James Inzalaco
38 Asbury Ave

- 9. The following needs to be discussed at the Planning Board Meeting
- A. Reasons for supporting the granting of the requested bulk variance relief, and/or design waivers and continuance of the existing condition non-conformities

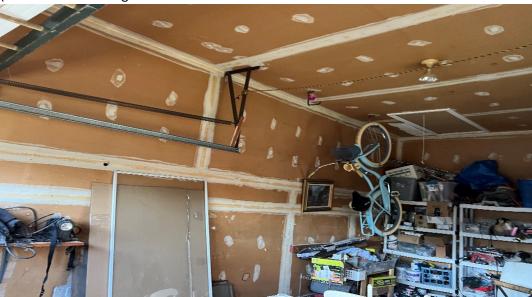
B. Per Borough definition "Floor area Ration, Usable" 50% of the floor area of the basement having a ceiling height of seven feet or greater shall be included in usable floor area ratio.

The ceiling height in the basement is 96 inches. The basement is primarily used for the home utilities (furnace, hot water heater, electrical box) in addition to our washer and dryer and storage. The basement square footage mirrors the upstairs, with the exception of the garage.

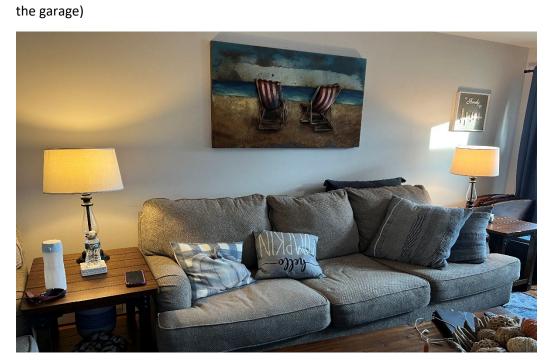
D. Photos of the existing conditions should be provided

(see below wall being removed between the livin

g space and
